North Dakota Department of Transportation

ADDENDUM 4 – JOB 19

TO: All prospective bidders on project NH-RSS-1-003(034)059, Job No. 19 scheduled for the November 14, 2014 bid opening.

Revised 10/31/2014	STATE	PROJECT NO.	SECTION NO.	SHEET NO.
	ND	NH-RSS-1-003(034)059	75	20

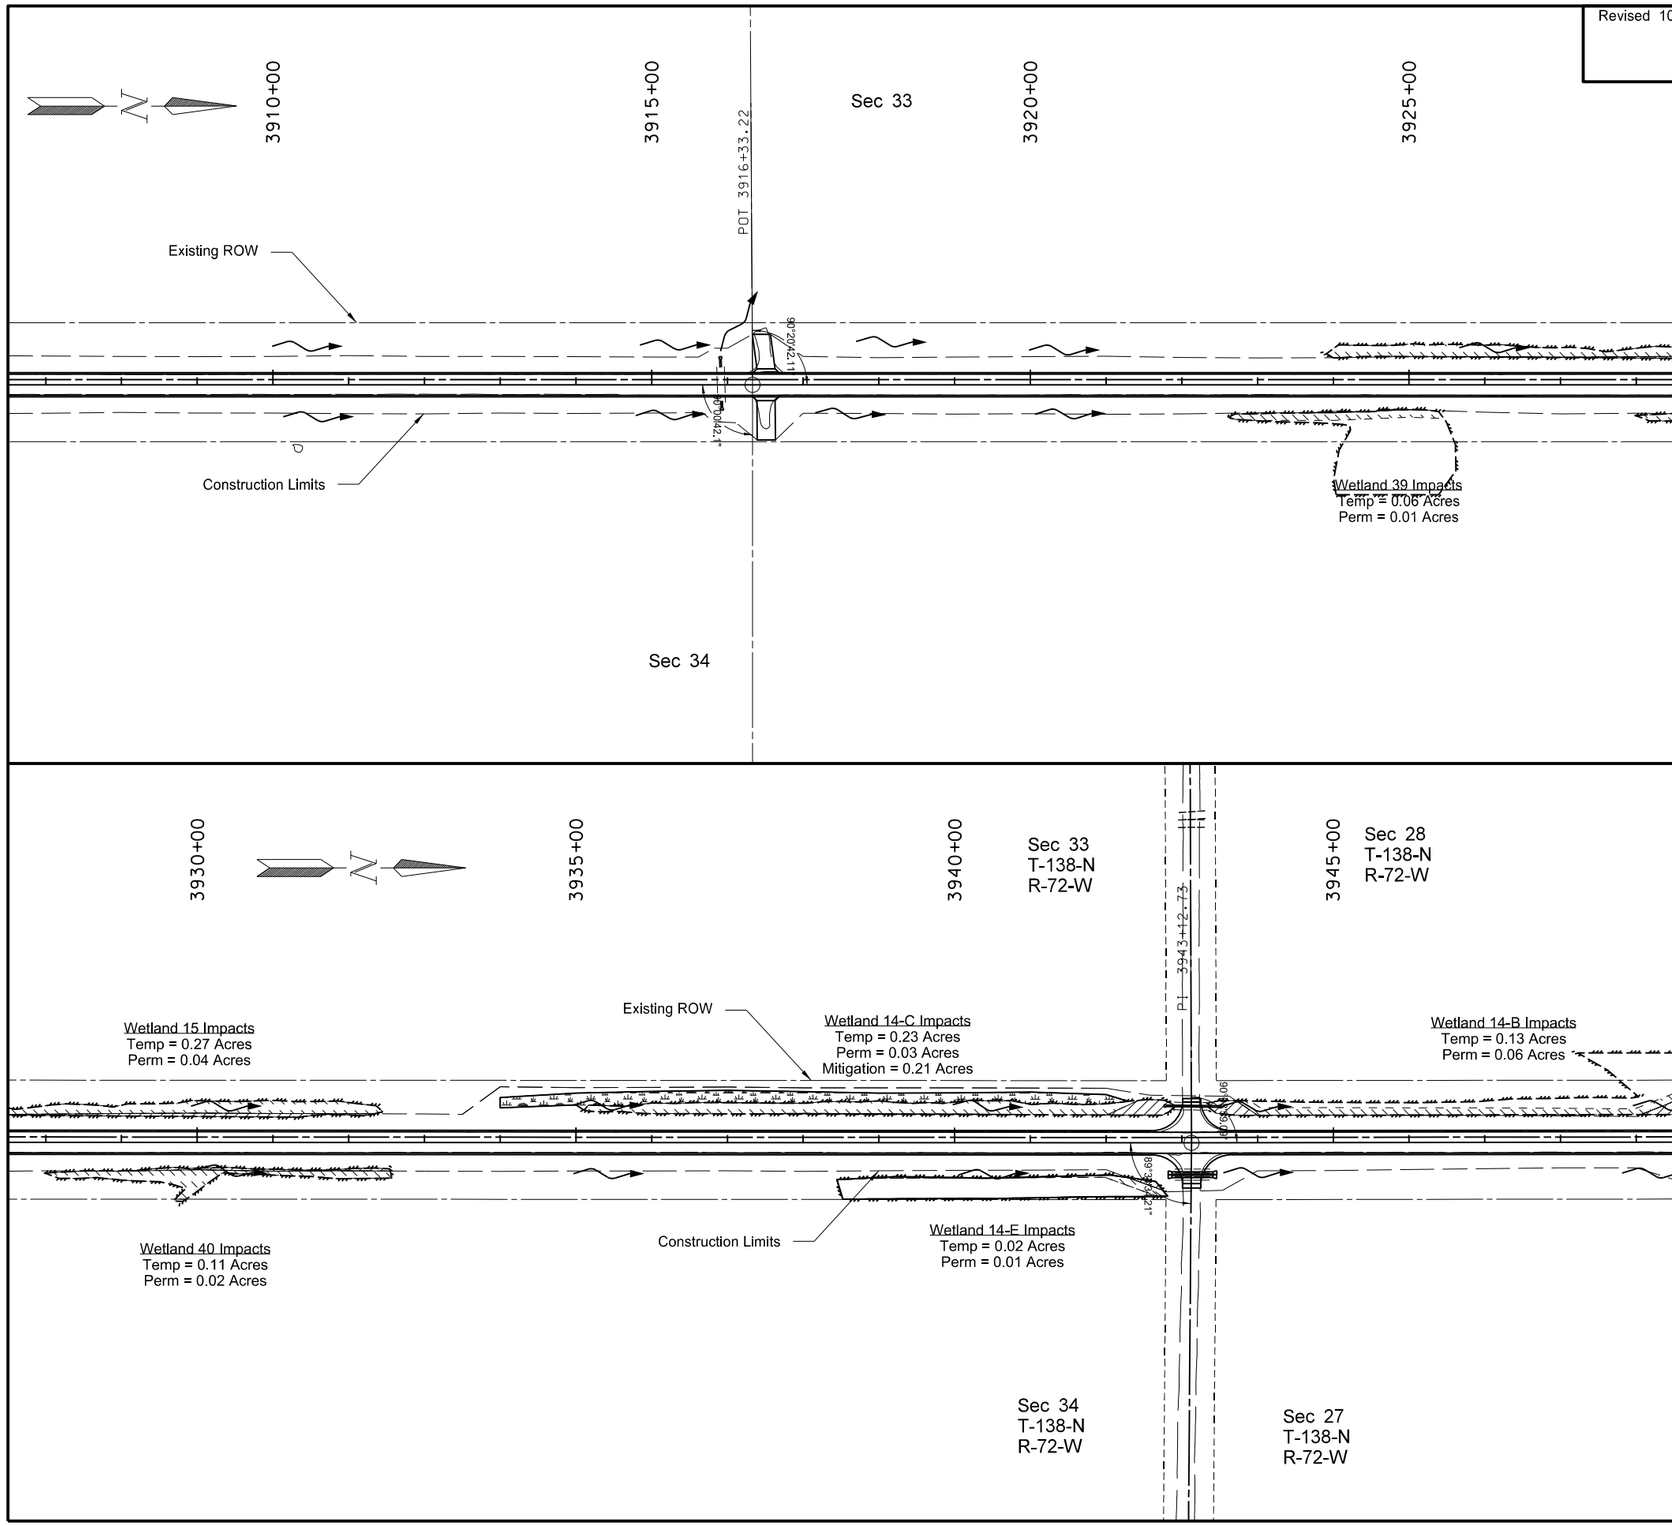
Section No. 75, Sheet No. 20:

- Updated Construction Limits.
- Wetland 14-E was added to the sheet along with impacts.
- Wetland Mitigation Lines were turned on.

Revised 10/31/2014	STATE	PROJECT NO.	SECTION NO.	SHEET NO.
	ND	NH-RSS-1-003(034)059	75	30

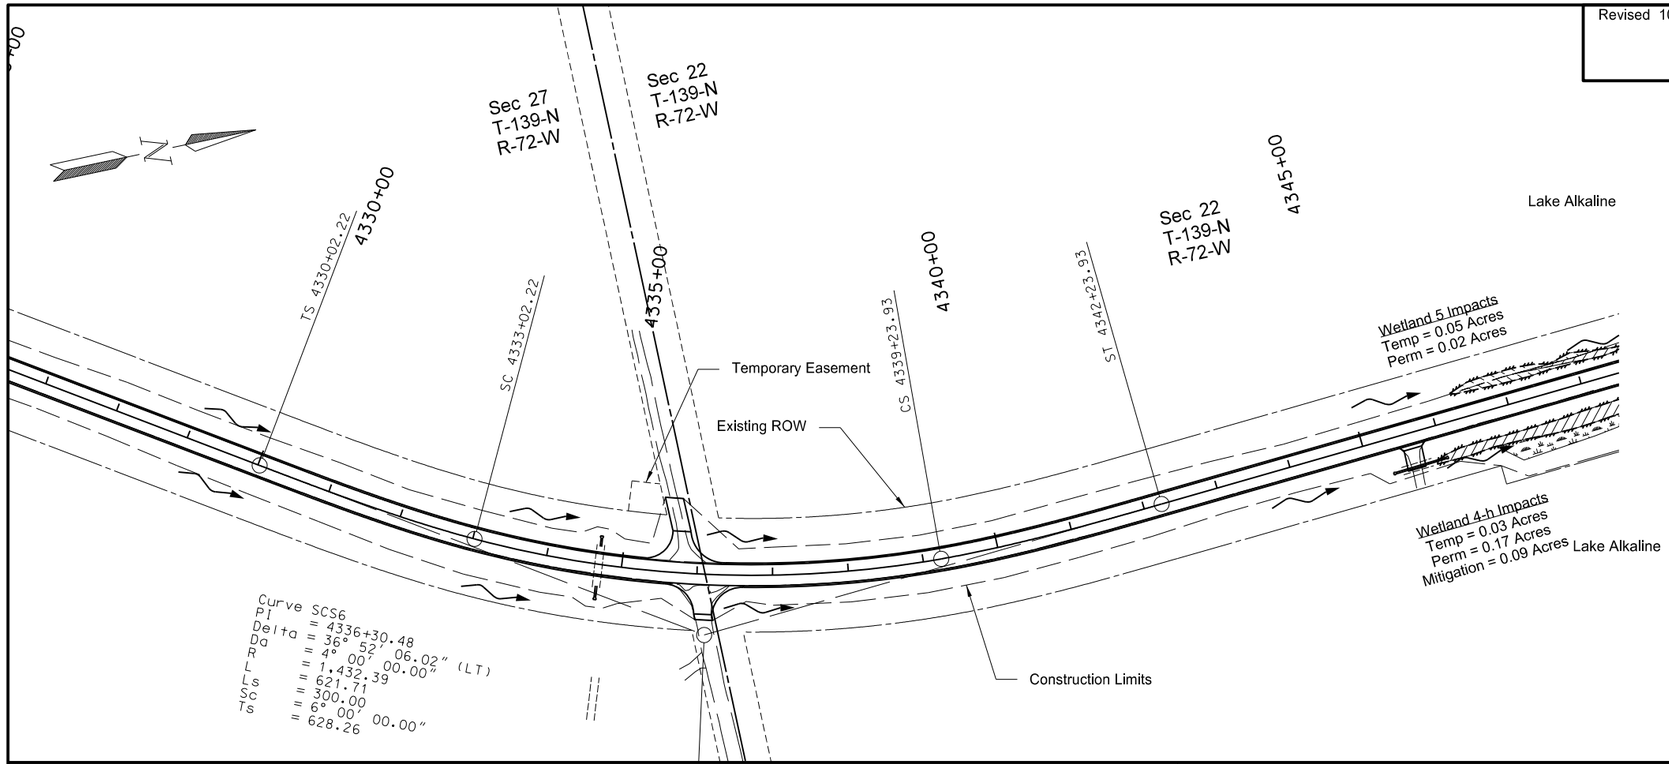
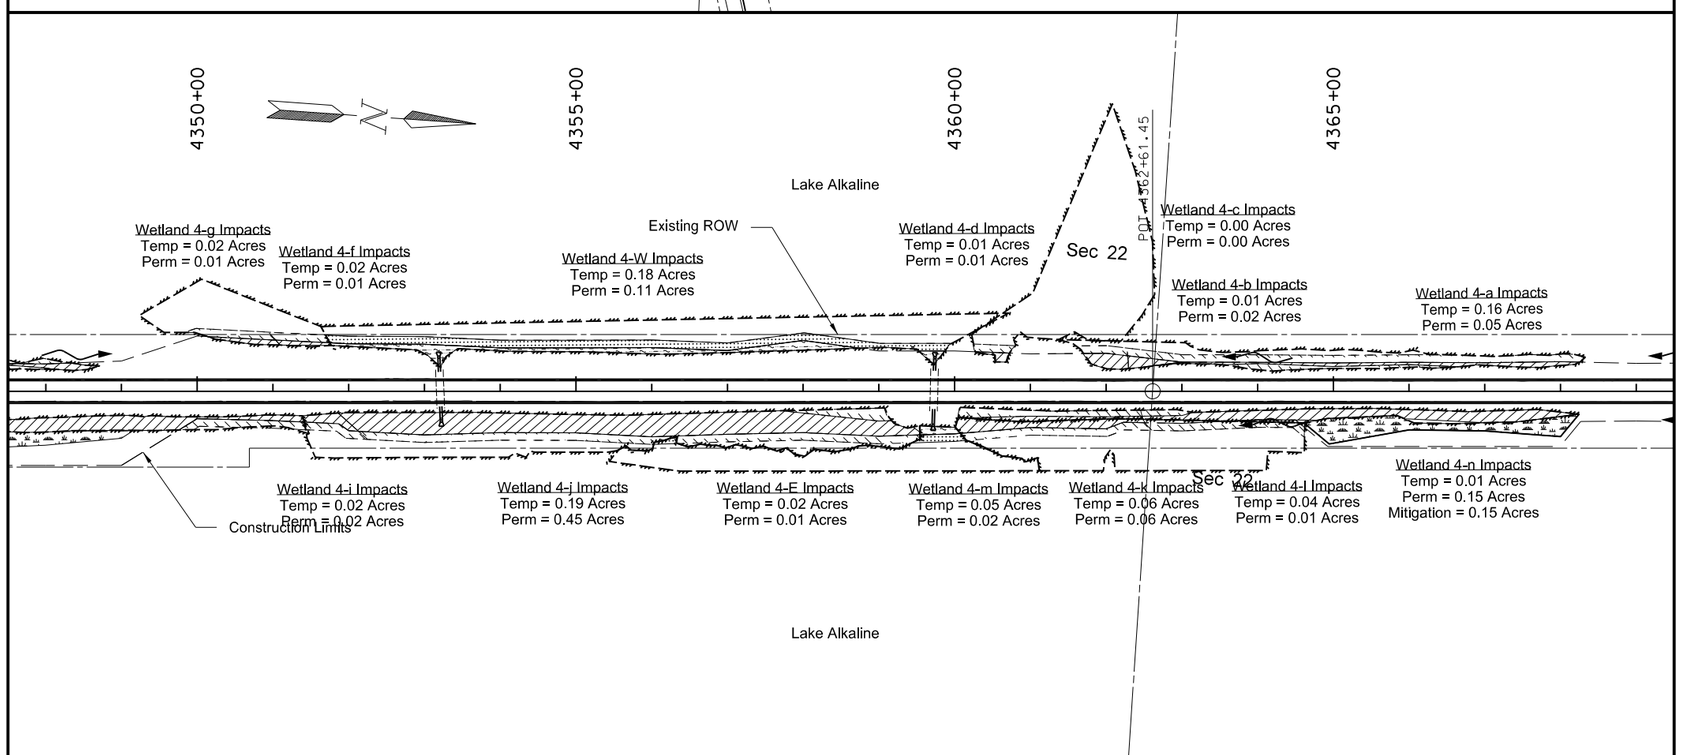
Section No. 75, Sheet No. 30:

- Wetland Impacts were revised.

Revised 10/31/2014	STATE	PROJECT NO.	SECTION NO.	SHEET NO.
	ND	NH-RSS-1-003(034)059	76	3

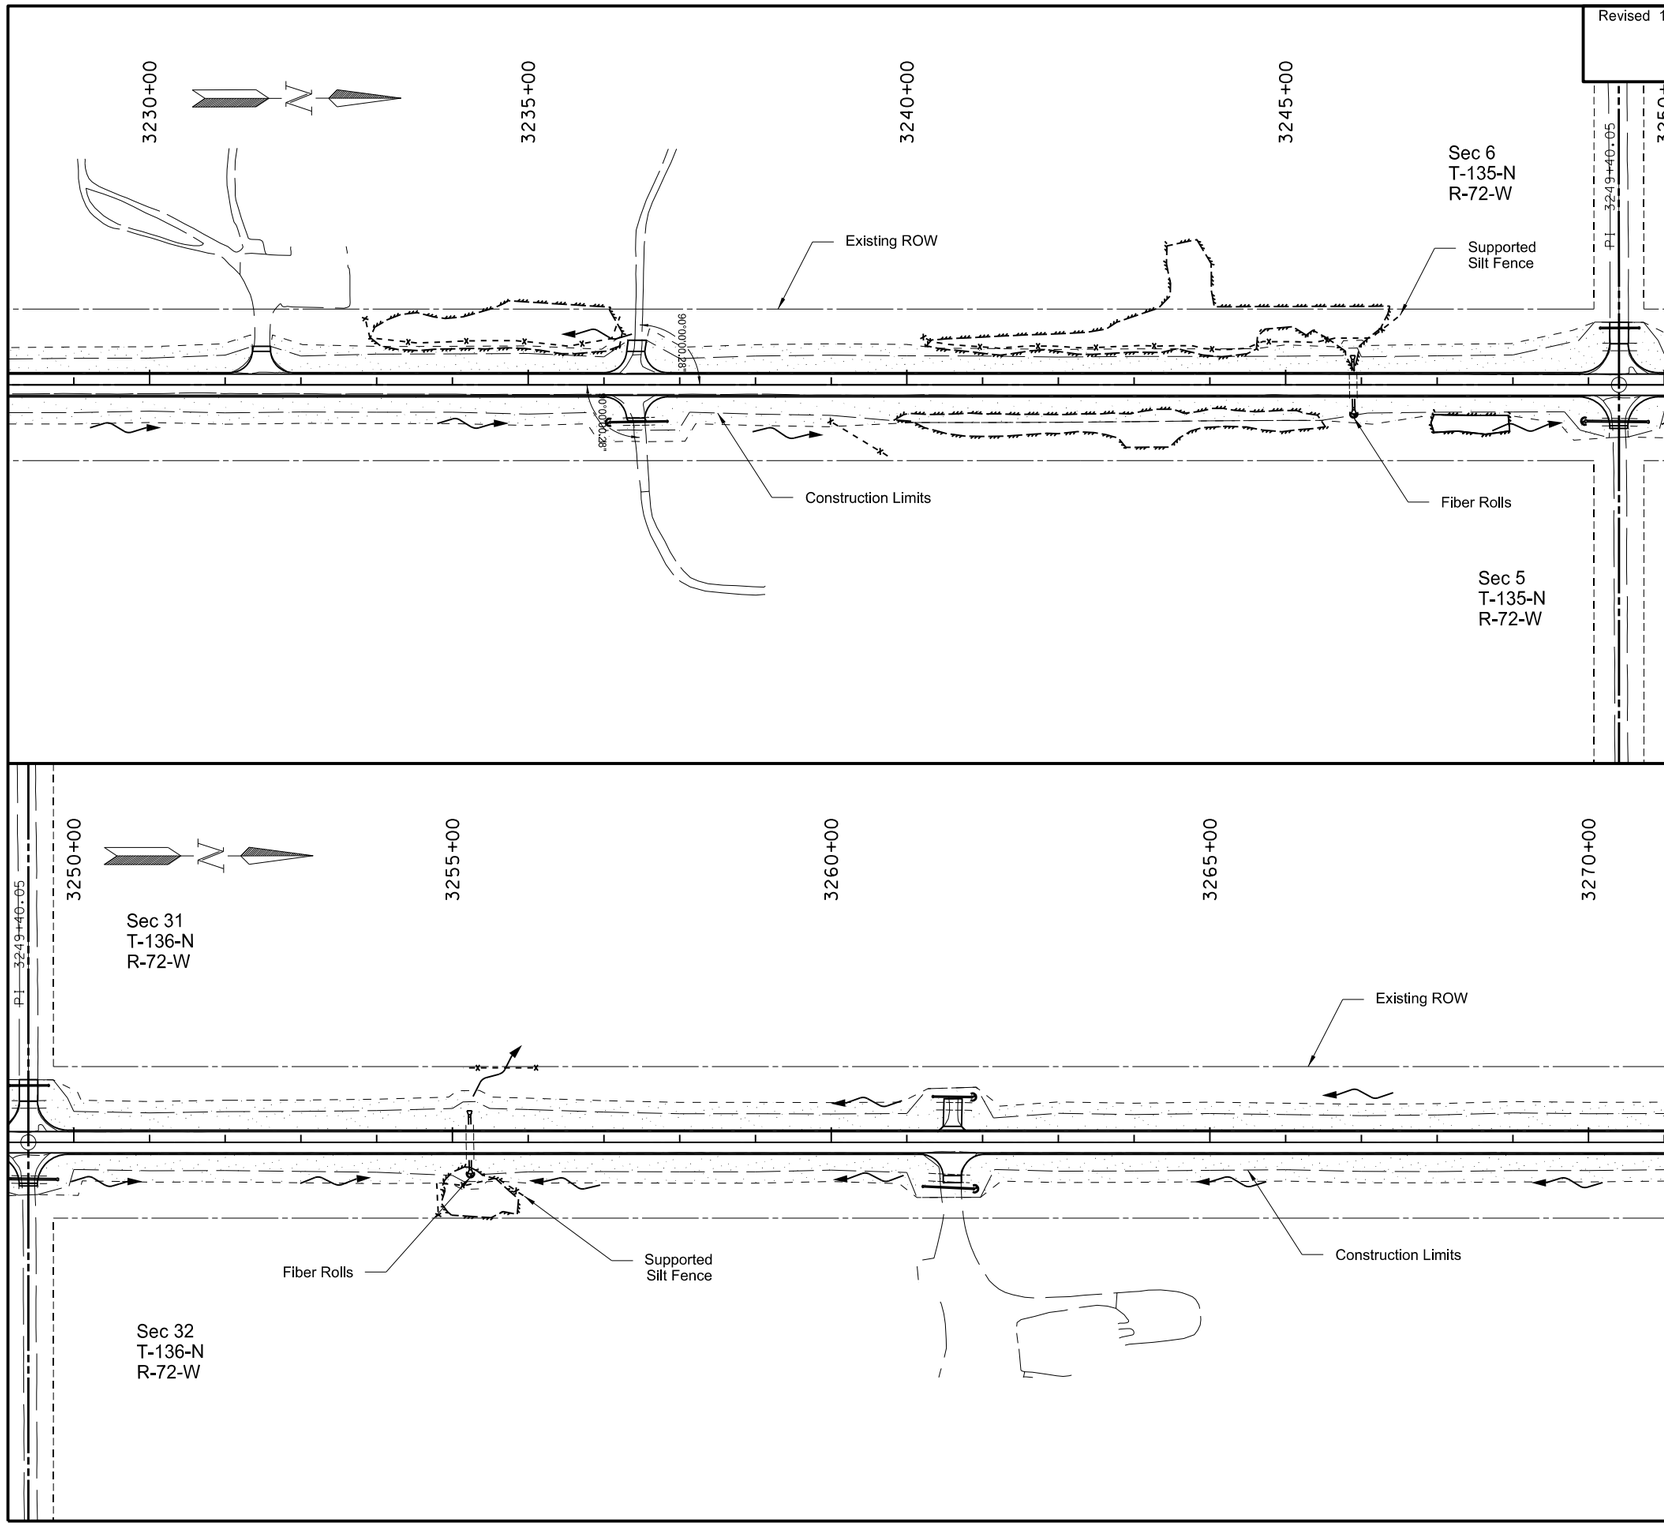
Section No. 76, Sheet No. 3:

- Wetland 44 was added to the sheet.
- Updated Construction Limits.

Revised 10/31/2014	STATE	PROJECT NO.	SECTION NO.	SHEET NO.
	ND	NH-RSS-1-003(034)059	76	20

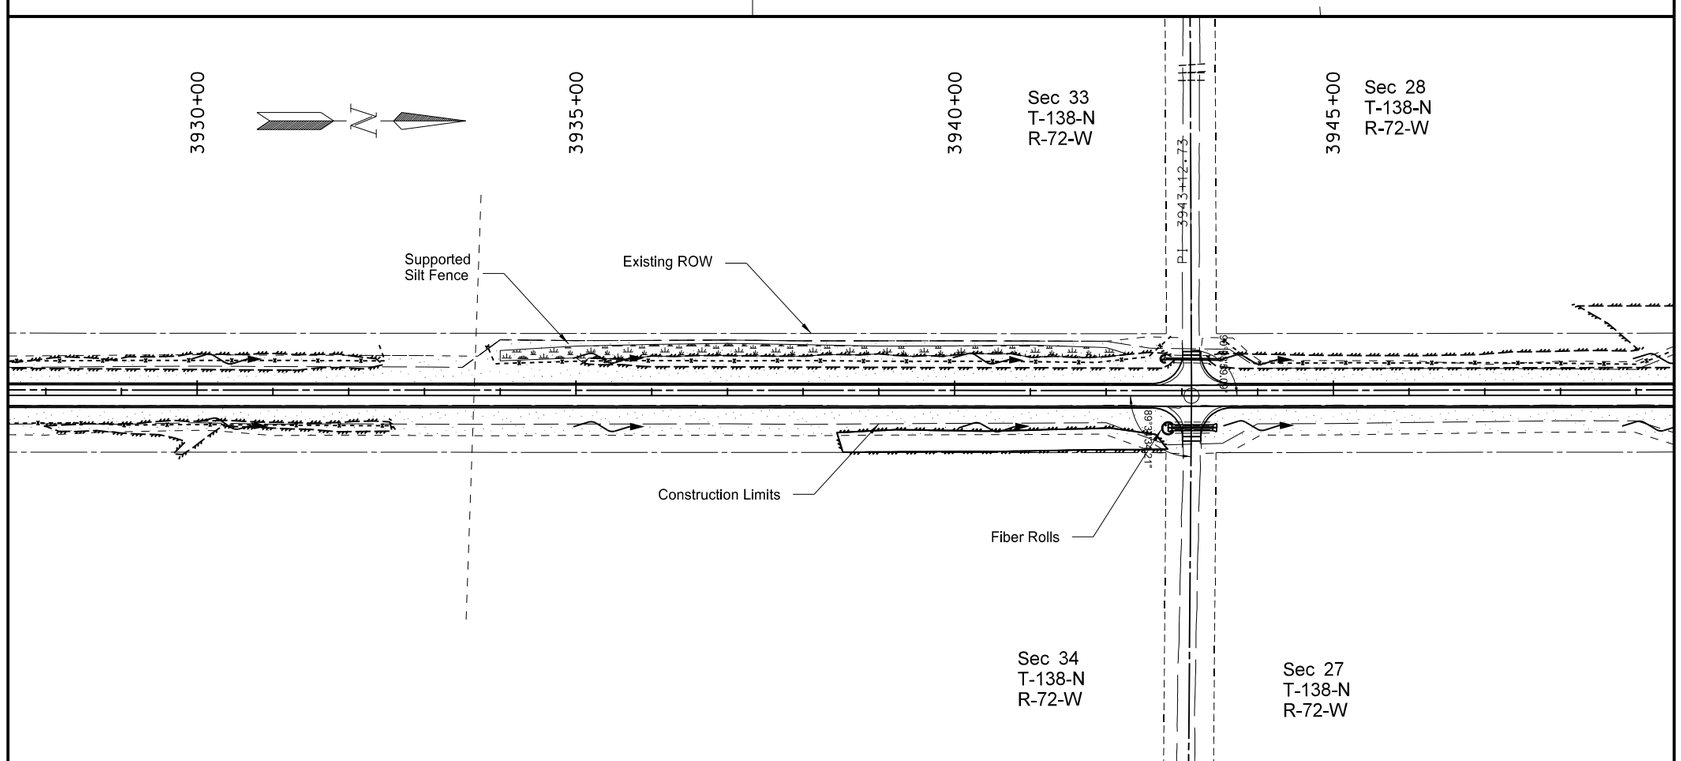
Section No. 76, Sheet No. 20:

- Updated the temporary seeding & temporary mulch boundary.
- Increased Silt Fence Supported Quantity at Station 3929+20 Rt. from 270 LF to 600 LF.
- Increased Removal Silt Fence Supported Quantity from 3,205 LF to 3,535 LF.
- Updated the Construction Limits.
- Added Wetland 14-E to the sheet.

Revised 10/31/2014	STATE	PROJECT NO.	SECTION NO.	SHEET NO.
	ND	NH-RSS-1-003(034)059	76	30

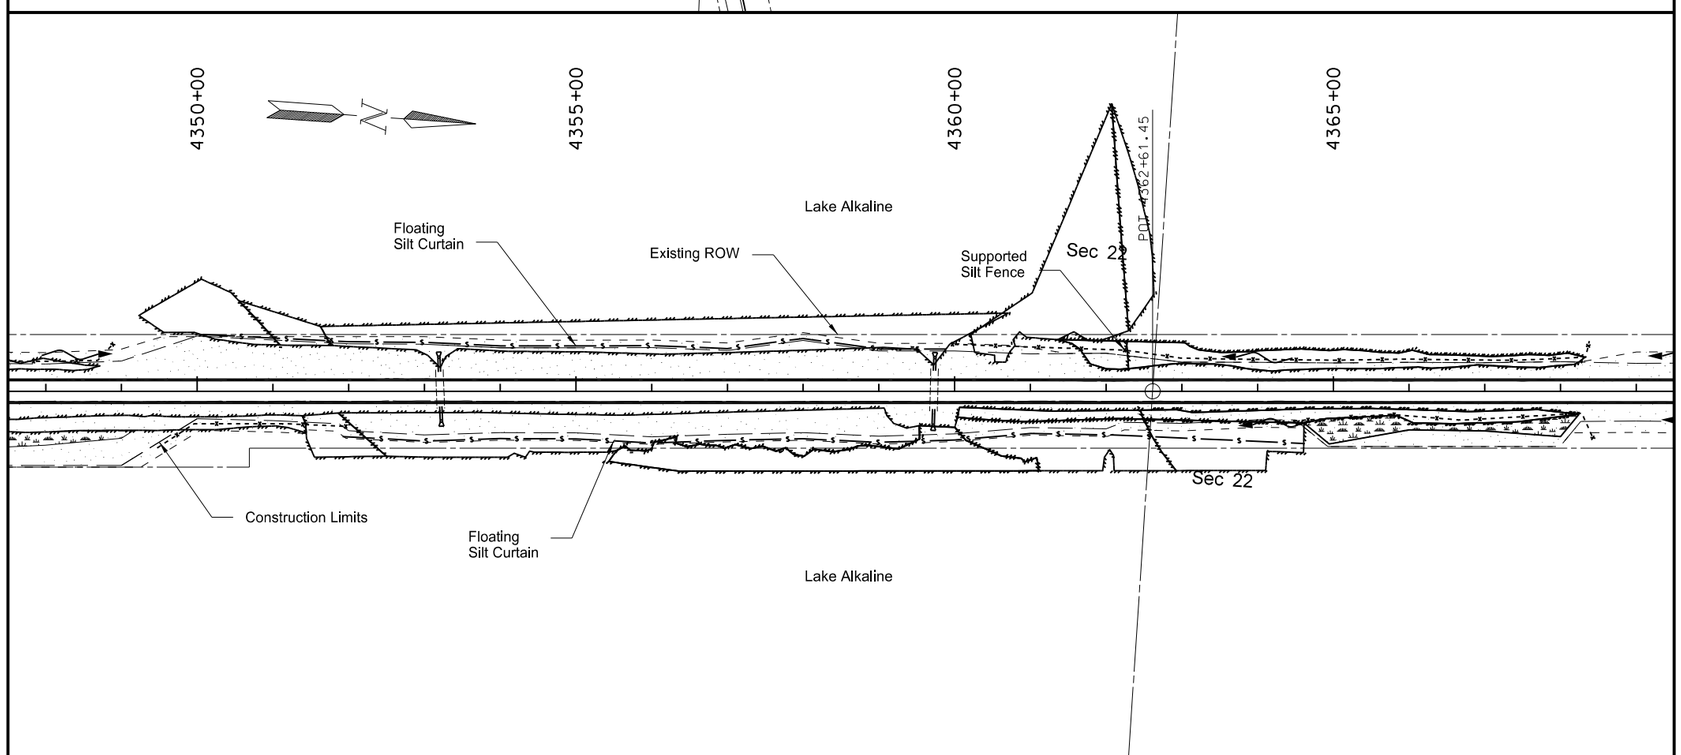
Section No. 76, Sheet No. 30:

- Wetlands were revised.
